RECALL BULLETIN 05V-262

DATE: SEPTEMBER 12, 2005
 MODEL YEAR: 1999 thru Early Production 2002
 CHASSIS MODEL: UD1200/UD1400
 BULLETIN NUMBER: SC-262

VOLUNTARY SAFETY RECALL CAMPAIGN NUMBER 05V-262: BATTERY CABLE INSPECTION AND/OR REPLACEMENT

Figure A1 (1999 & 2000 MY)

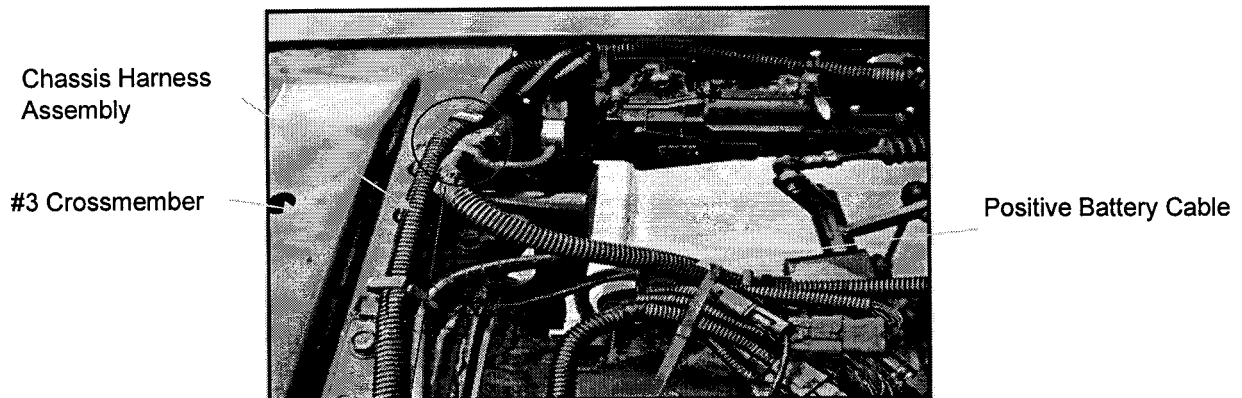
If the battery cable is not damaged inspect the Positive Battery Cable for proper routing as illustrated in Figure A1 and A2. Re-route the cable correctly as necessary. Proceed to Step 3.

Clamp the battery cable securely with the Chassis Harness to the cross member using the welded harness clip.

NOTE*: If the 3rd frame cross member is missing the welded retaining clip or is broken, use a Tie Strap PN 01552-00043 (from the Safety Recall Parts Kit) to secure the battery cable to the chassis harness as shown in Figure A2.

Figure B

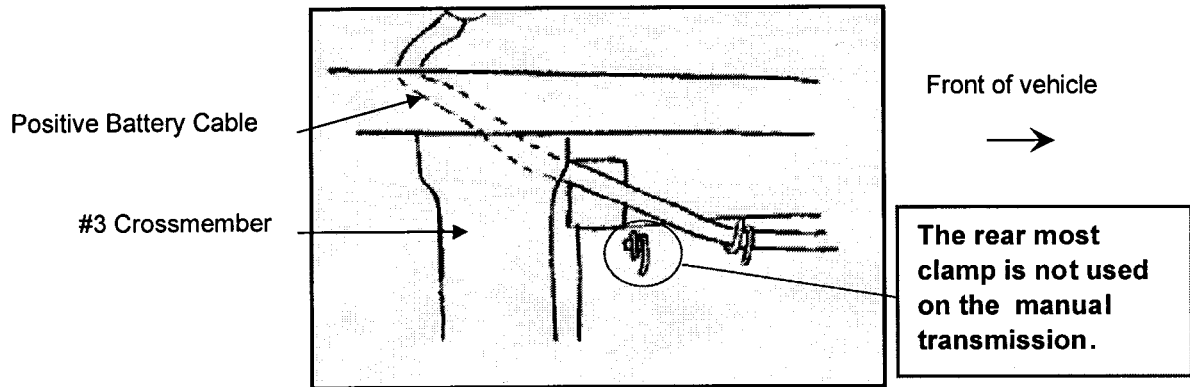
NOTE: Manual Transmission Models: Do not use the rear most retaining clip on the transmission shift cover to secure the battery cable, see Figure B.

Step 3

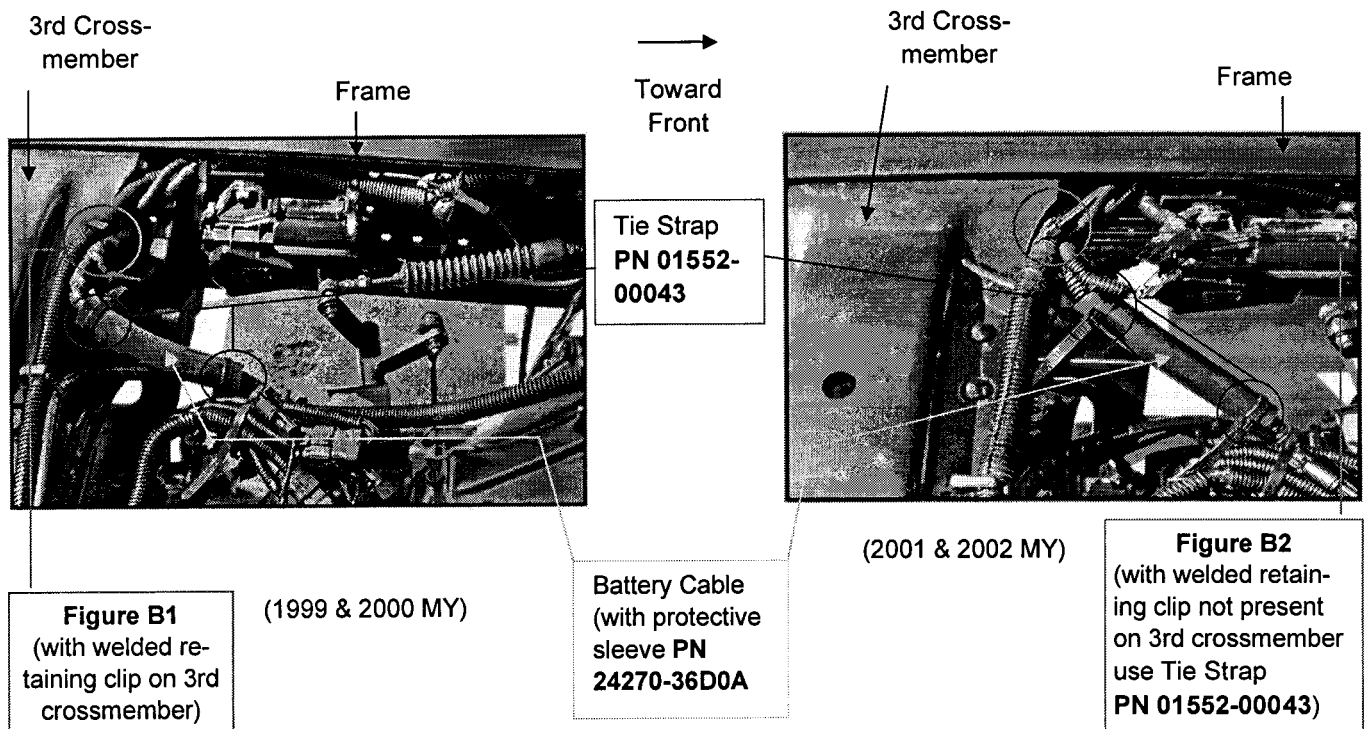
Install the battery cable Protective Sleeve PN 24270-36D0A from the Safety Recall Parts Kit around the battery cable.

Use 2 Tie Straps PN 01552-00043 to secure the Protective Sleeve at each end as shown in Figure B1 if the welded retaining clip is present.

Use 2 Tie Straps PN 01552-00043 to secure the Protective Sleeve at each end and a 3rd tie strap to secure the battery cable to the chassis harness at the crossmember as shown in Figure B2 if the welded retaining clip is not present.
